## **ADDENDUM NO. 6**

**TO: ALL PLANHOLDERS OF THE BUTTERFIELD PARK – PHASE 1 PROJECT**

**RE: BID OPENING DATE/TIME CHANGE, QUESTIONS/RESPONSES, AND  
ADDED/REPLACED PLAN SHEETS**

Date 11-07-2022  
Scale 1"=60'  
Drawn:AB/RB/TM  
Checked: FR  
Job J22108  
Sheet 1 of 5

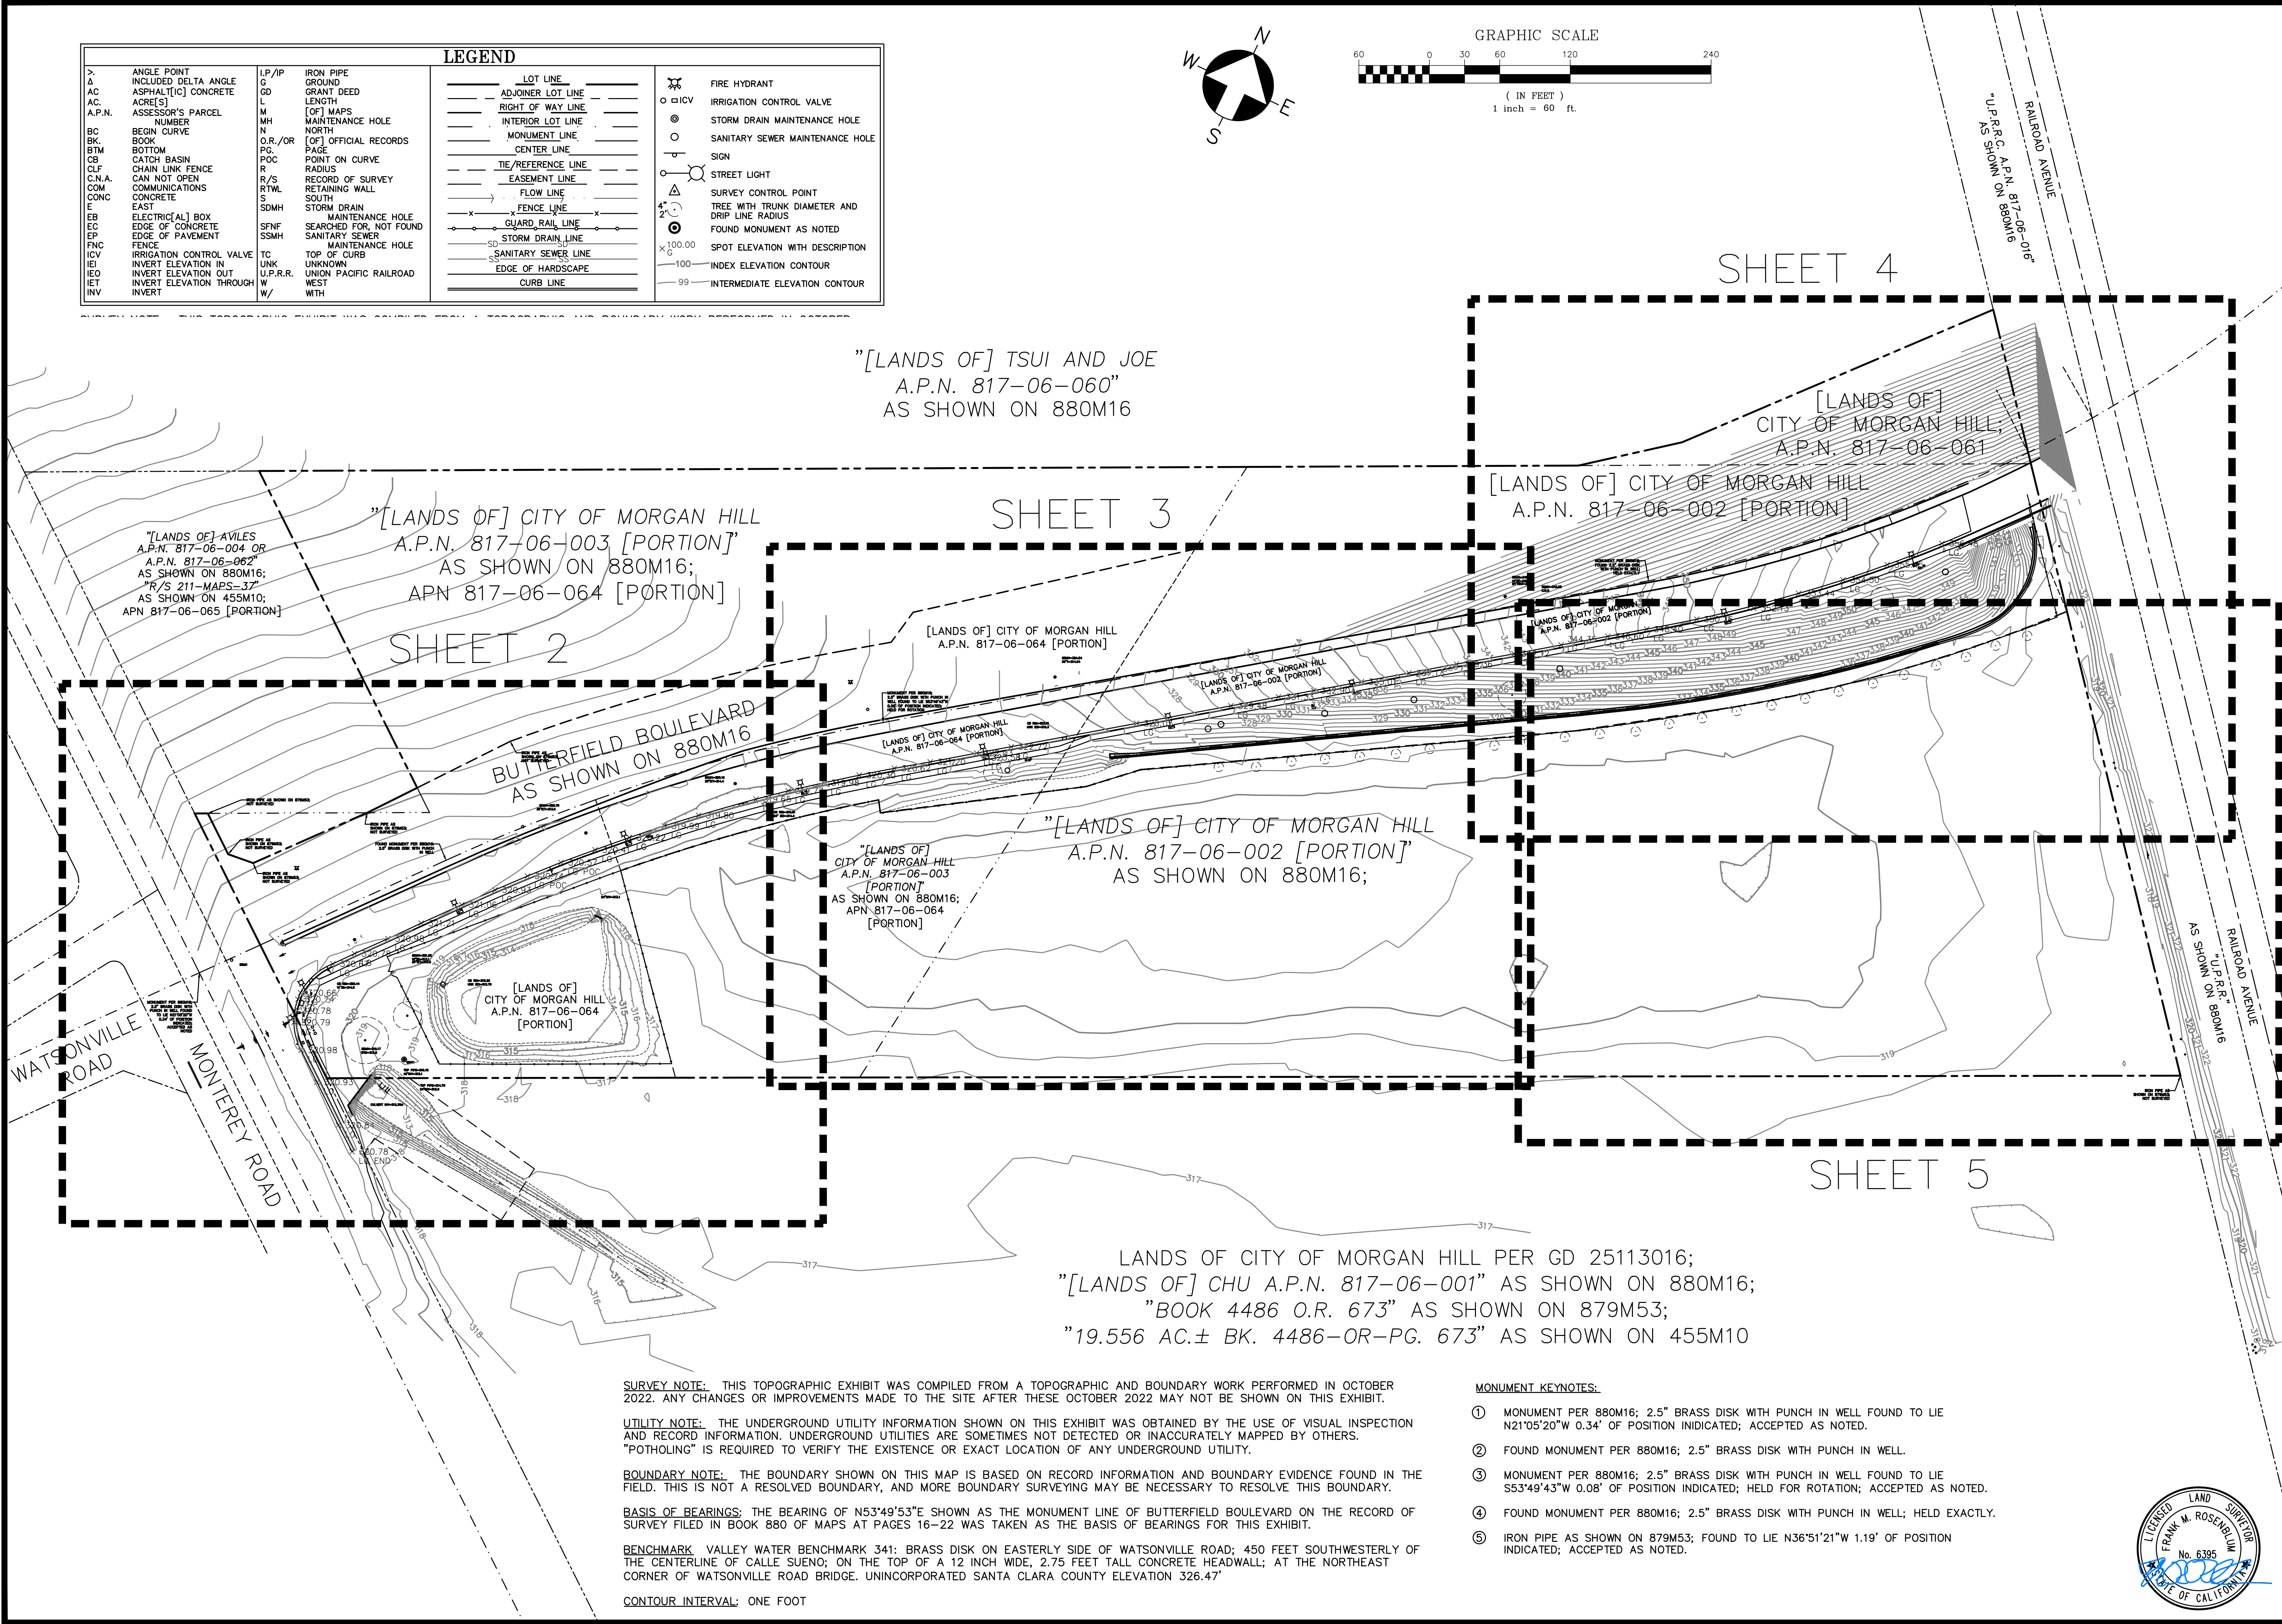
- d. Question #48-D to City: What are the existing grades of the site? How is the Contractor to quantify the amount of dirt to be excavated to obtain subgrade on the site?  
City's Response to Question #48-D: Refer to the attached five (5) new "Topographic Exhibit" sheets and one (1) "Fill Added Exhibit" sheet prepared by Underwood & Rosenblum, Inc. Add all sheets to the bid set.

FILE NUMBER:  
PRINT DATE:  
SHEET NUMBER:  
L4.1

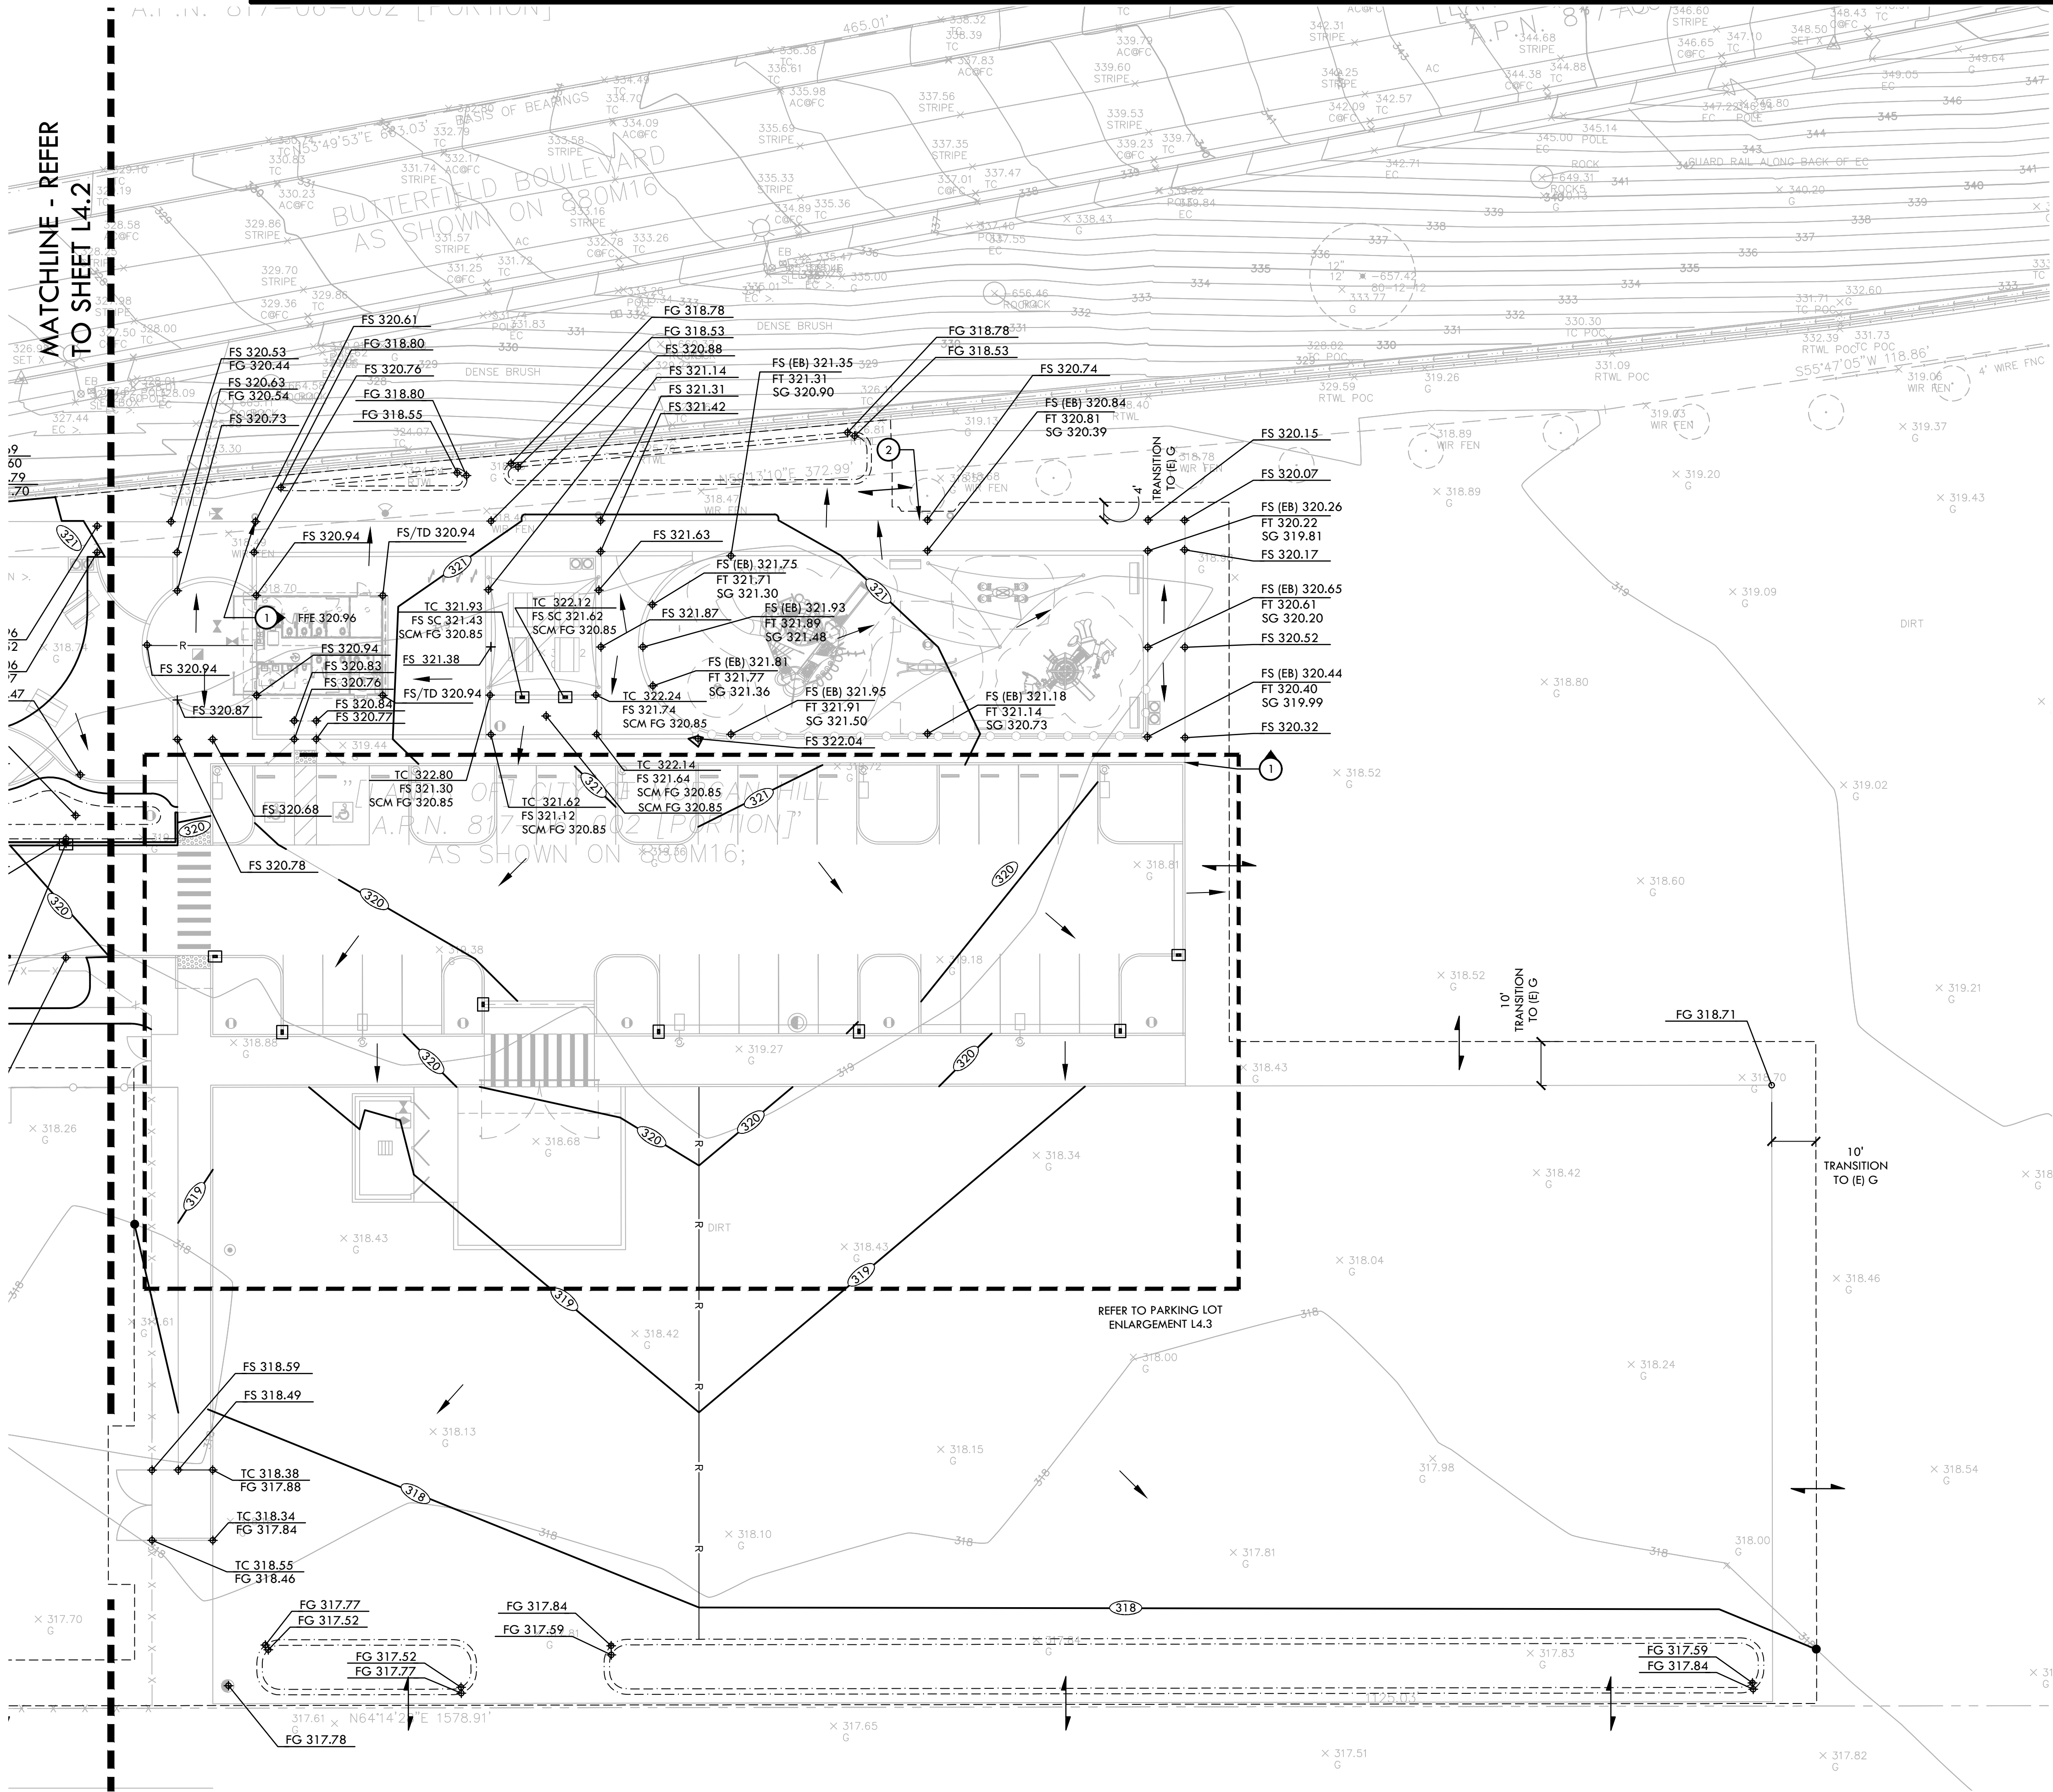
12. **Replace one sheet of the Grading Plans (Sheet L4.1) with attached, revised Sheet L4.1.**

3	95% SUBMITTAL	11/28/23	VERDE	WORK ACCEPTED:	INSPECTOR:	DRAWN: MK	DESIGN: VERDE	HOR: AS SHOWN
4	BID SUBMITTAL	1/31/24	VERDE			CHECKED: DM		VERT: AS SHOWN
5	ADDENDUM #6 REVISION: NEW SELF-RETAINING AREAS NEAR PROPERTY LINE 924/24	02/02/24	CITY			APPROVED:	DATE:	JOB NUMBER: 2214701
NO.	DESCRIPTION	DATE	BY	DATE:		SCOTT C. GREER REG. 56679	EXP. DATE 6-30-2025	
Revisions
